RE: Independent Hydrogeological Review of  
Recent Data and Studies Related to California  
American Water's Proposed Monterey  
Regional Water Supply Project  
Weiss Job No. 466-2148

This draft report documents Weiss Associates (Weiss's) independent hydrogeological review of data and studies related to California American Water's (Cal-Am) proposed Monterey Regional Water Supply Project (MRWSP). The MRWSP is expected to extract predominately seawater pumped from a planned well field near the Monterey Bay shoreline in the City of Marina California.

Figure 2-6

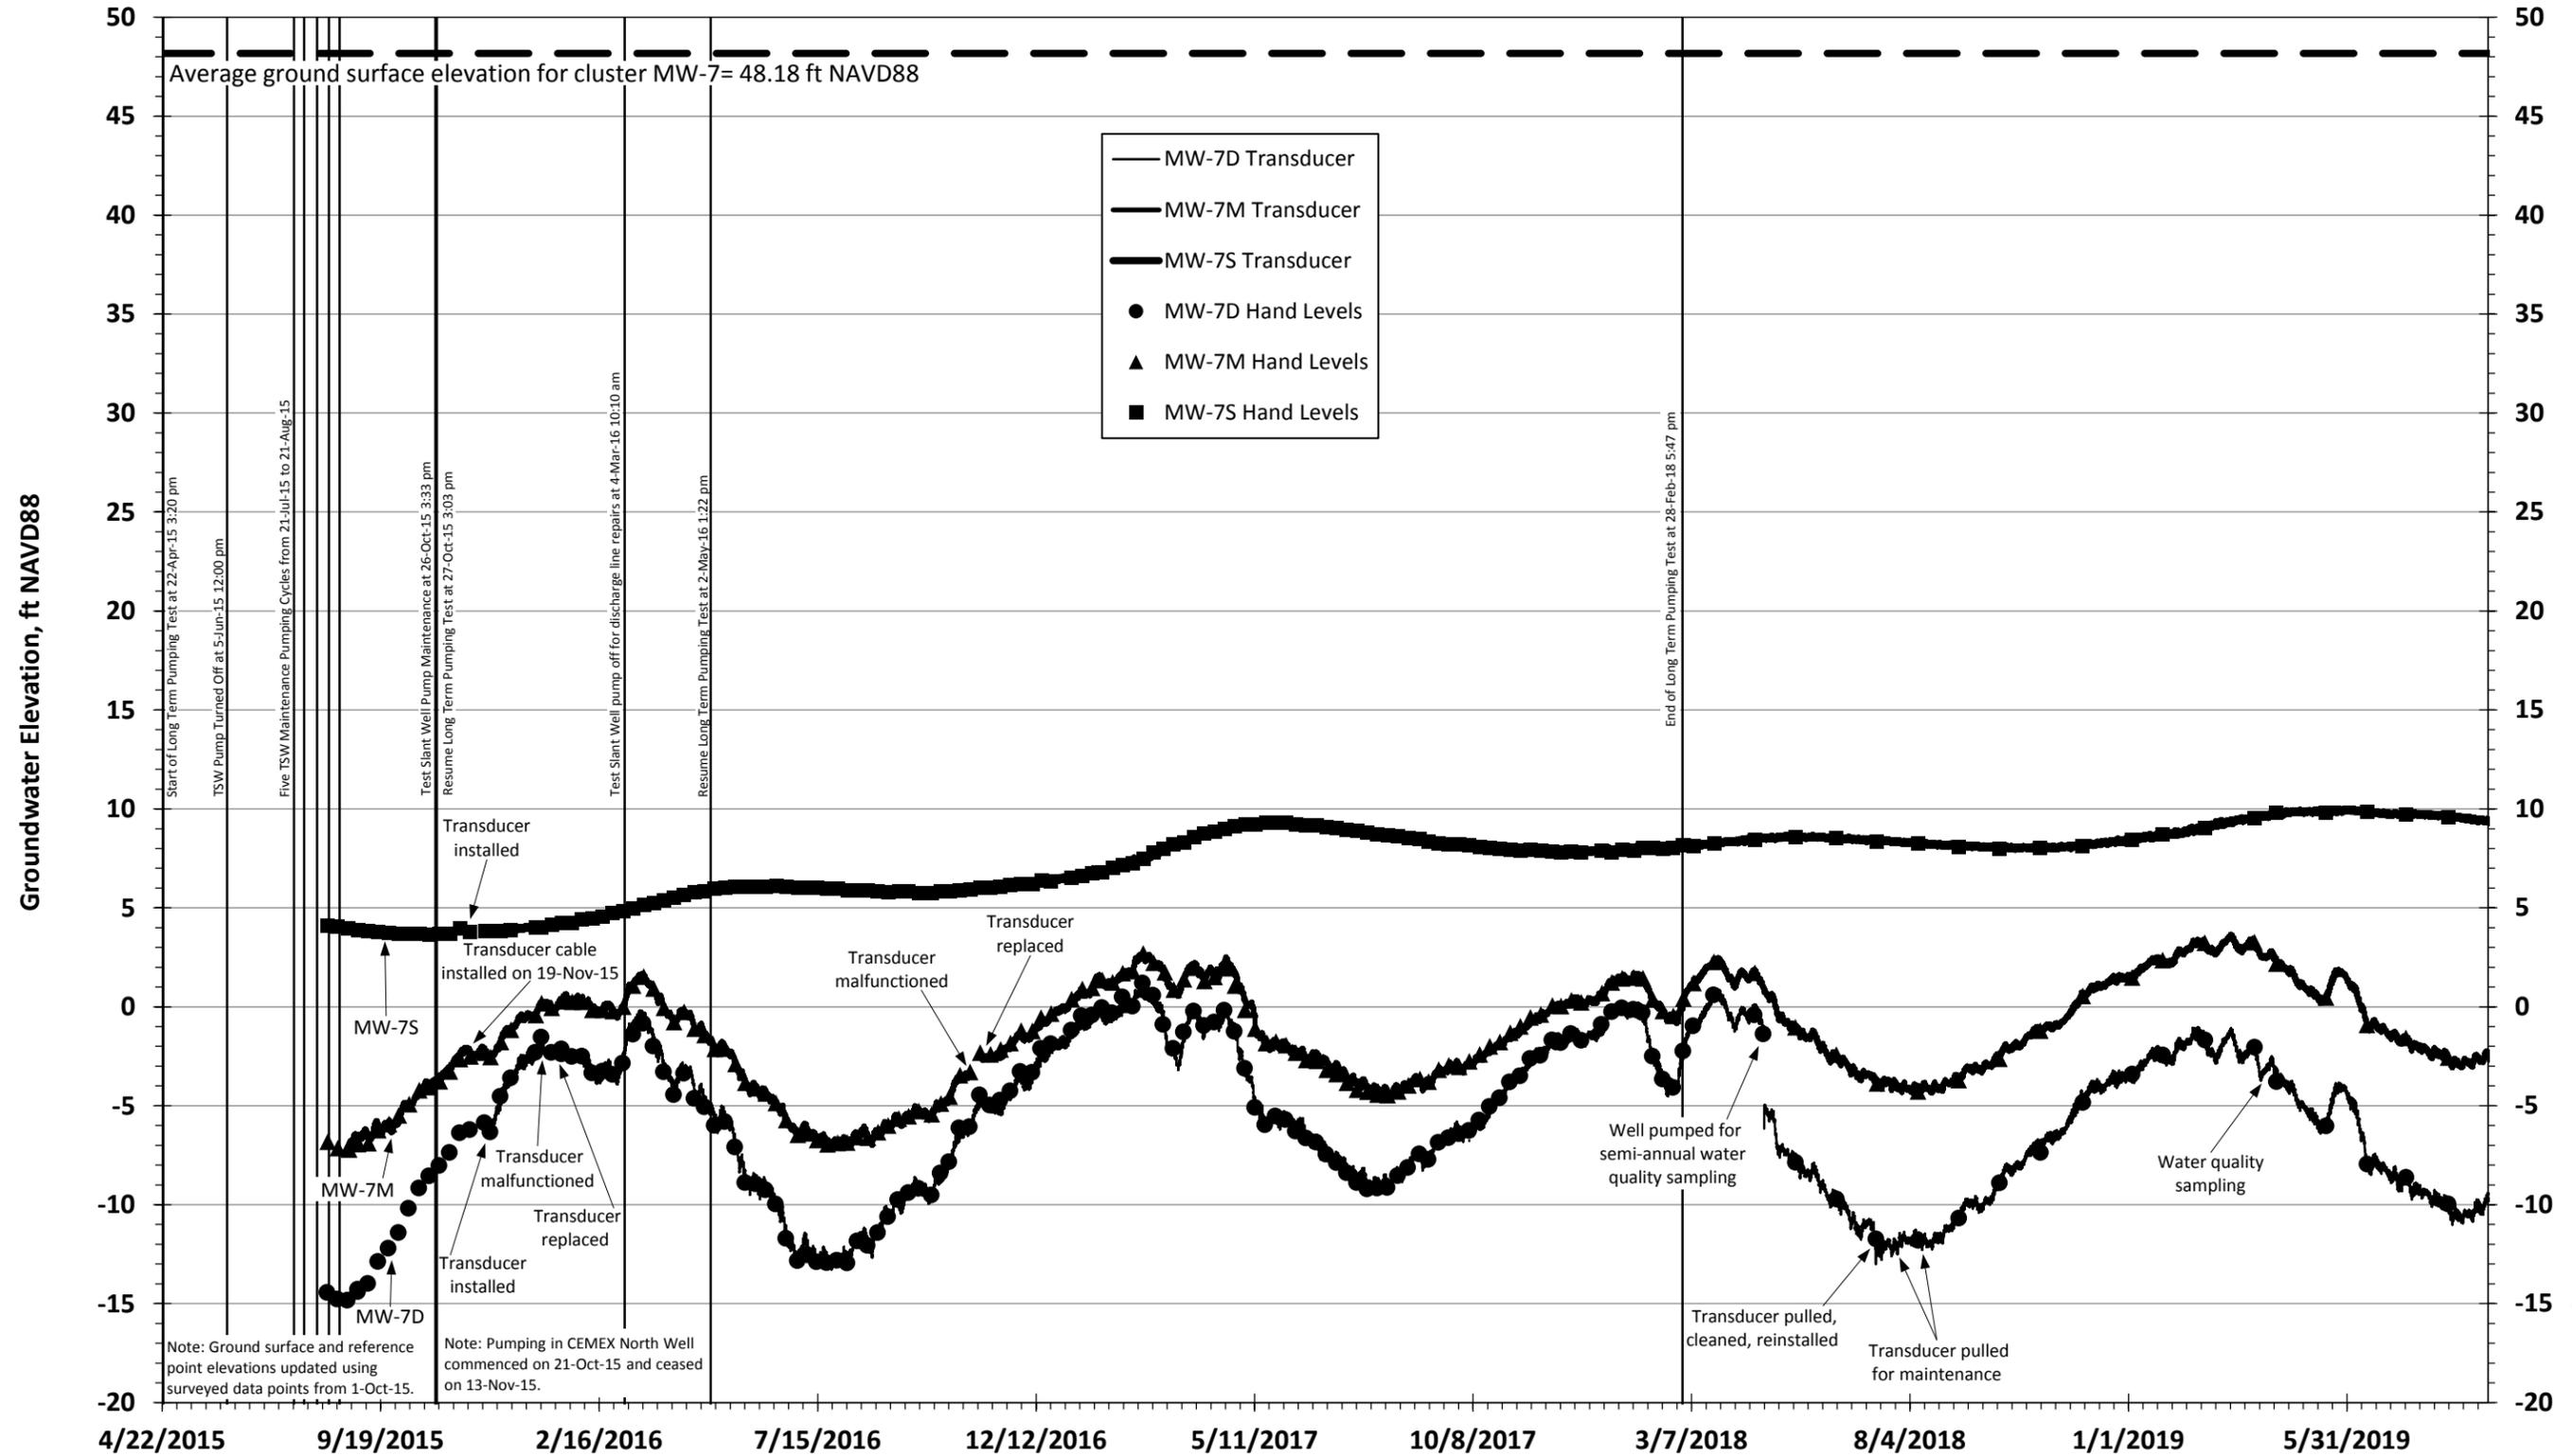
Further evidence of hydraulic separation between the Dune Sand and 180-Foot Aquifers at the MW-7 comes from water level trends at MW-7S relative to MW-7M. MW-7S rose approximately 6 feet between October 2015 and June 2017, from approximately 4 feet NAVD88 (1-foot above mean sea level [MSL] which is at 3 feet NAVD88) to 9 feet NAVD88, presumably in response to above-average rainfall following a period of drought. During this time, the water level in MW-7M remained at or below MSL (3 feet NAVD88) (Figure 7).

Figure 10

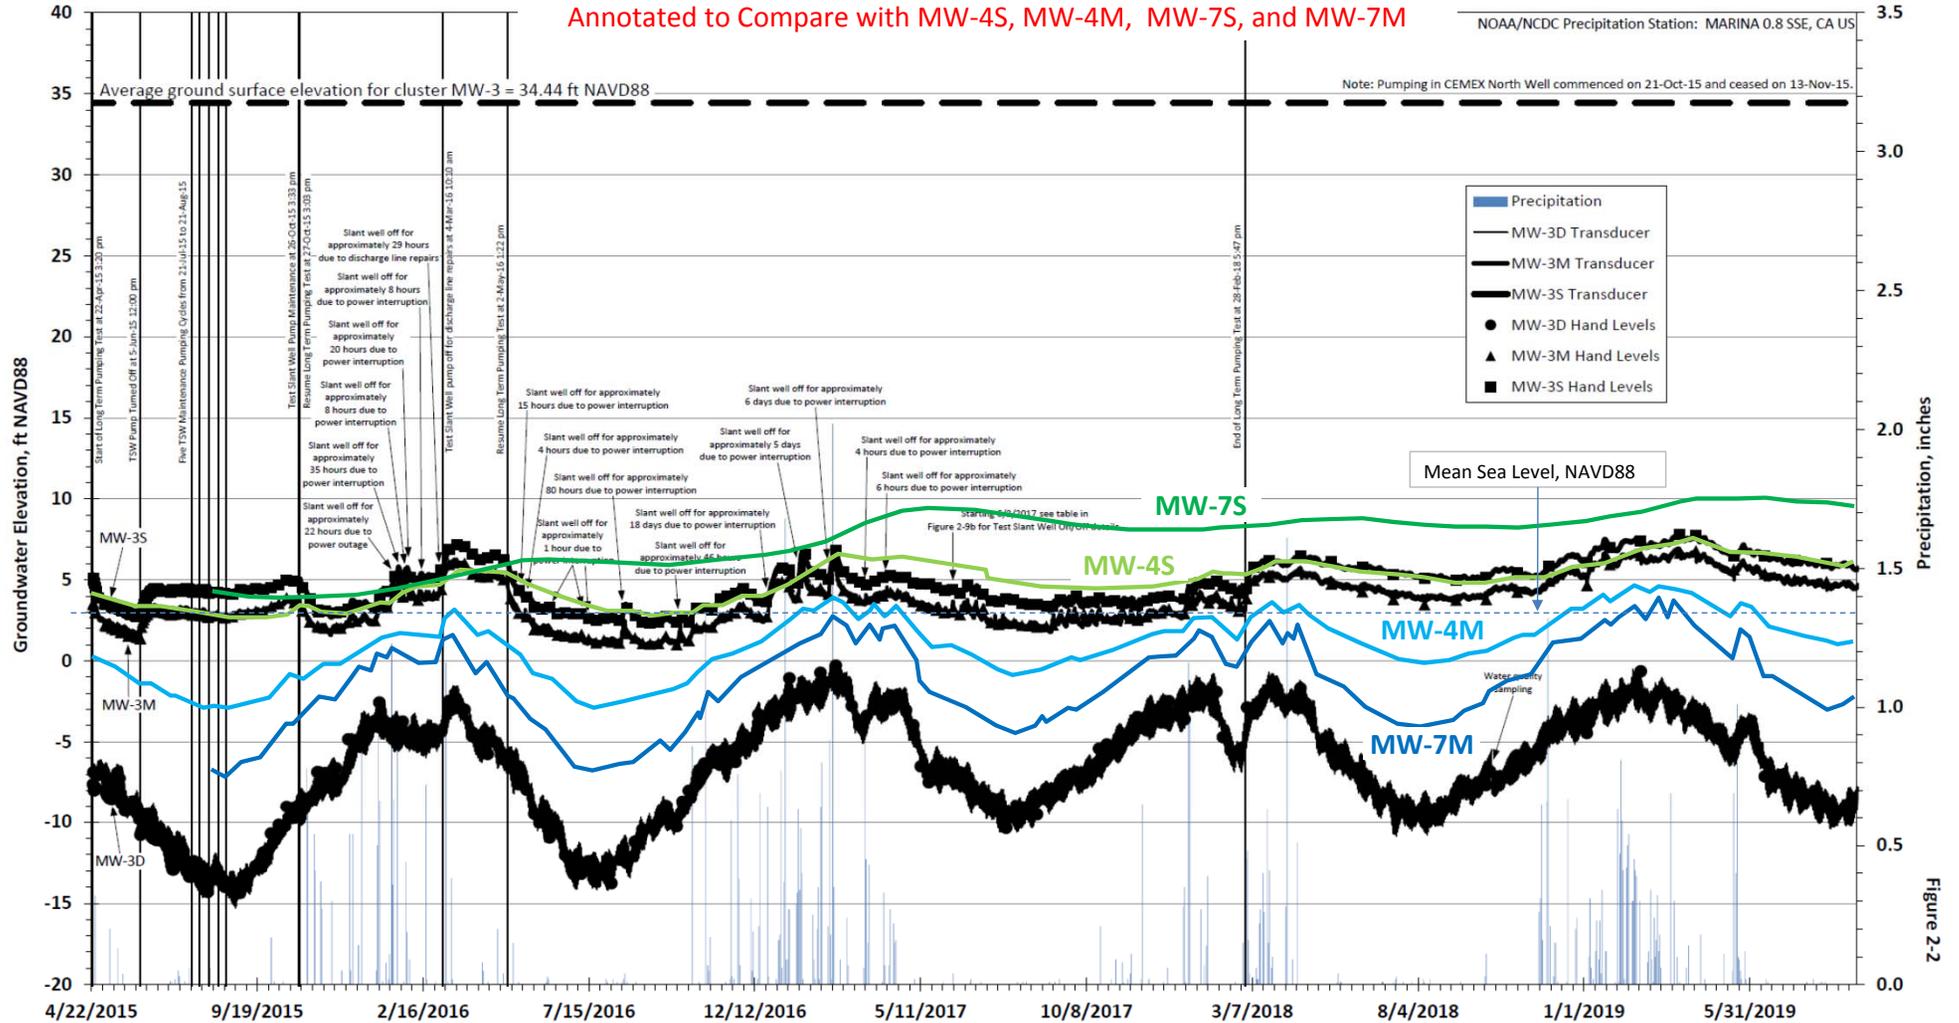
To illustrate changes in groundwater gradients over time between well clusters MW-3, MW-4, and MW-7, the hydrographs of MW-4S, MW-4M, MW-7S, and MW-7M have been overlain in shades of blue and green on the MW-3 hydrographs (Figure 10) to allow comparison of water levels between these wells. The groundwater gradient between the wells over time can be calculated by selecting two of the “S” or “M” hydrographs and dividing the difference in feet between their water levels at any point in time by the distance in feet between the two wells.

Throughout the April 2015 to September 2019 monitoring period, the groundwater gradients from MW-3M to MW-4M to MW-7M (180-Foot Aquifer) have been consistently landward, at values ranging from 0.0004 to 0.004, regardless of whether or not the TSW was pumping. The magnitude of the upper end of this range is higher than the 0.0004, 0.0007, and 0.0011 landward gradients used by the 2016 North Marina Ground Water Model (NMGVM)<sup>2016</sup> to generate groundwater capture maps for the Dune Sand and 180-Foot Aquifers.<sup>7e</sup> Indeed, the average landward gradient between these wells is approximately 0.002, nearly double the steepest gradient that was modeled. The result of this difference is that had the well field been pumping from 2015 to 2019, the average capture zone in the 180-Foot Aquifer would be smaller than the smallest of the suite of capture zones depicted in the output from NMGVM.<sup>2016</sup>

In the Dune Sand Aquifer between MW-3S to MW-4S, gradients have ranged from flat to 0.0011 landward when the TSW was not pumping, to up to 0.0012 seaward when it was pumping. Between MW-4S and MW-7S (with one exception) the gradient has been consistently seaward at values ranging up to 0.001 during non-TSW pumping conditions, and from 0.0003 to 0.0012 during

# Figure 18

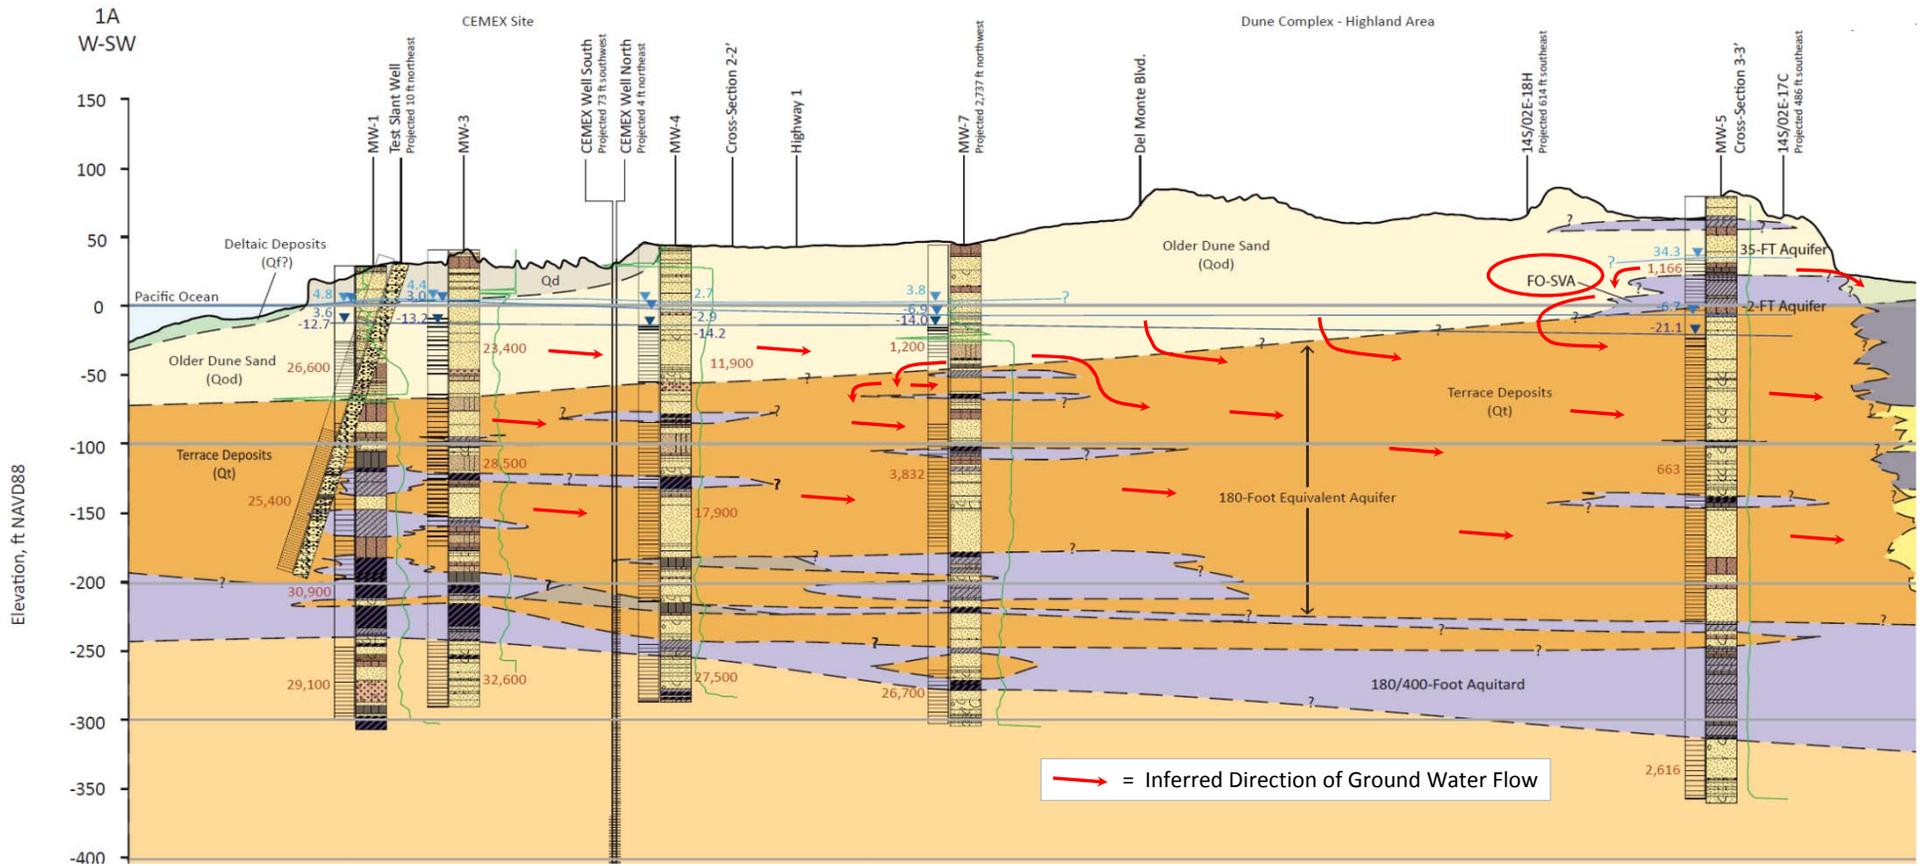
While not illustrated specifically, CSM-1 is described extensively in the Final EIS/EIR<sup>(7a, 7b, 7c, 7e, 7f, and 10)</sup> and shown on Figure 18 which was developed for this report by annotating Geologic Cross Section 1A-1A’ (Figure 12). Key features of CSM-1 are:

- East of MW-7, the FO-SVA is discontinuous and there are two hydrostratigraphic units above it: the Dune Sand Aquifer, and above that, the “perched/mounded” aquifer. The FO-SVA is shown as being continuous south of MW-7 on Geologic Cross Section 3-3’ (Figure 15), and south of MW-5 on Geologic Cross Section 4-4’ (Figure 16); however, in between these areas, it is considered discontinuous as shown on all cross-sections that include MW-7 (Figures 12, 13, and 16). As stated in Section 4.4-8 of the Final EIR/EIS,<sup>(7a)</sup> “The Perched A Aquifer appears to be hydraulically connected with a shallow aquifer local to the Monterey Peninsula Landfill area (referred to as the “-2- Foot” Aquifer) and the Dune Sand Aquifer near CEMEX area (HWG, 2017; see Appendix E3, TM2). The Dune Sand Aquifer is at a lower elevation and not hydraulically connected to the inland perched, mounded aquifers, namely the shallow, local 35-Foot Aquifer at the Monterey Peninsula Landfill and the “A” Aquifer in the Fort Ord Area (approximately 1.5 miles inland). The “A” Aquifer near Fort Ord is at a higher elevation than the Salinas Valley A-Aquifer and is perched on the Fort Ord-Salinas Valley Aquitard.”

- The clay layer at MW-7 separating the Dune Sand Aquifer and 180-Foot Aquifer is of limited extent, such that water held up by it at a higher elevation flows laterally until it encounters the edges of the clay layer, or gaps in it, then flows vertically down into the 180-Foot Aquifer as depicted on Figure 18.

**Figure 27**

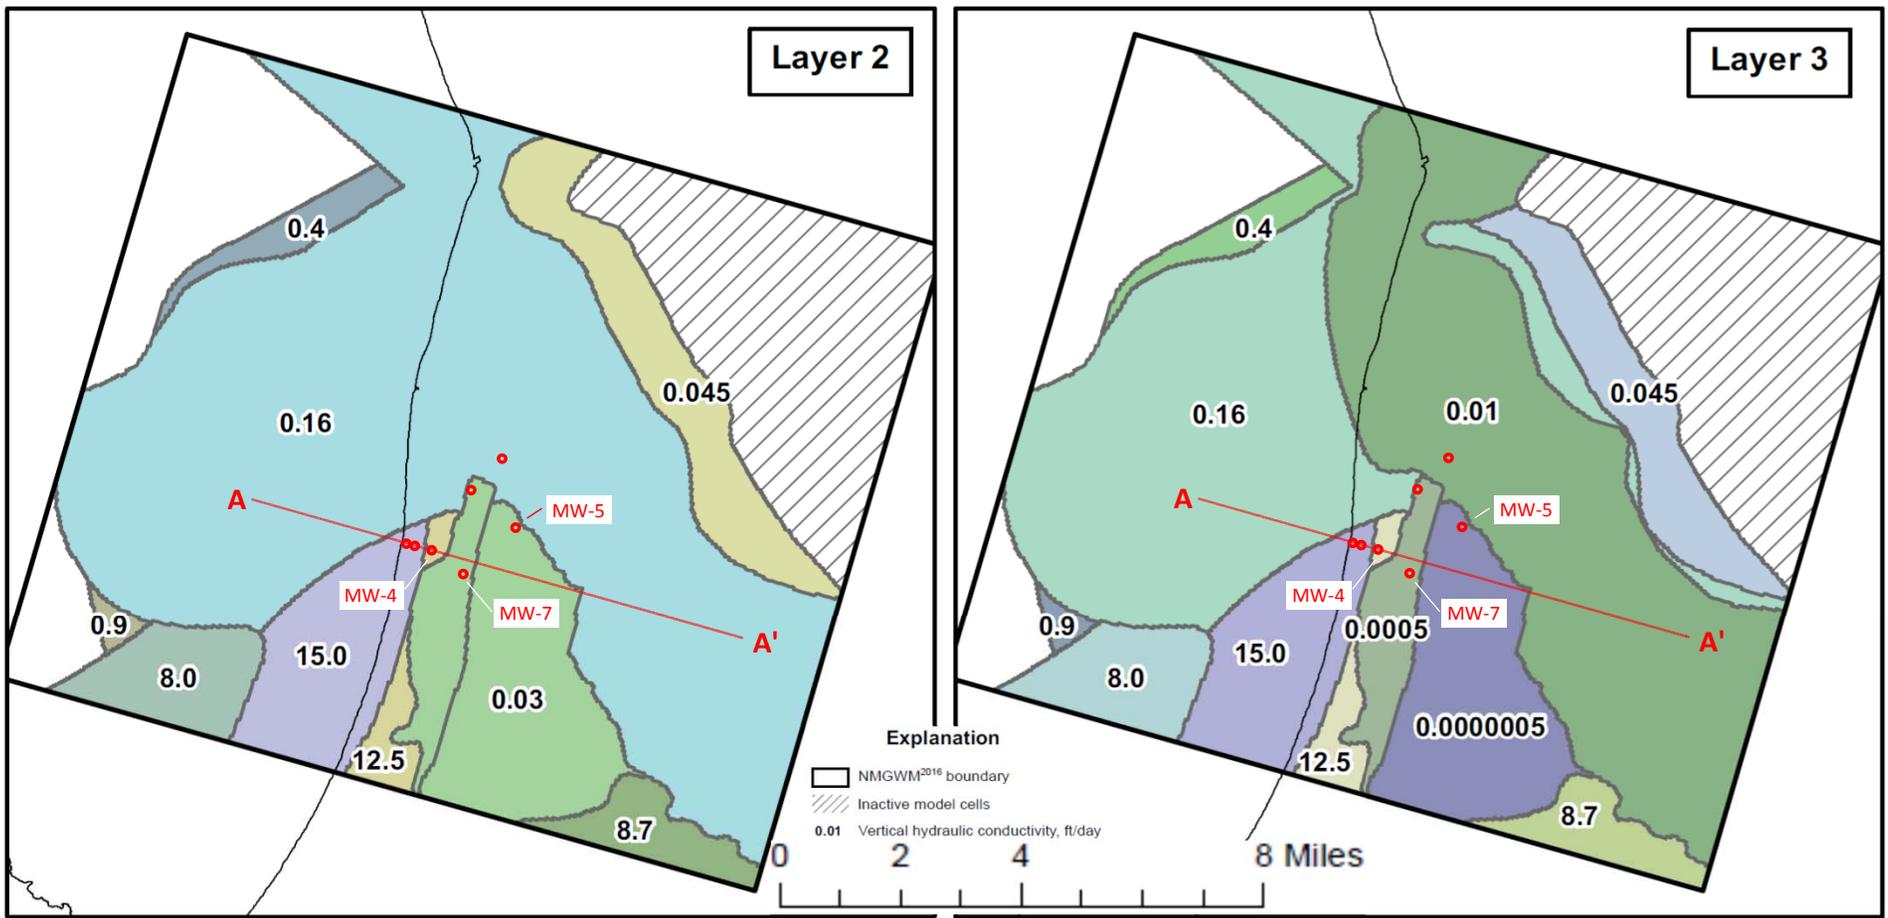
- The horizontal hydraulic conductivity (HK) assigned to the Dune Sand Aquifer inland of the well field, represented by model Layer 2, Zones 16 and 20 (Figures 27 and 29), is 2 and 4 feet per day (ft/day), respectively, which is very low for dune sand. These model values are at the bottom end of the range in values from other sources (Figure 27) of up to 250 ft/day for Zone 16 and 400 ft/day for Zone 20. Indeed, all of the surrounding Zones in Layer 2 are assigned HK values of 1 to 3 orders of magnitude higher than Zones 16 and 20.
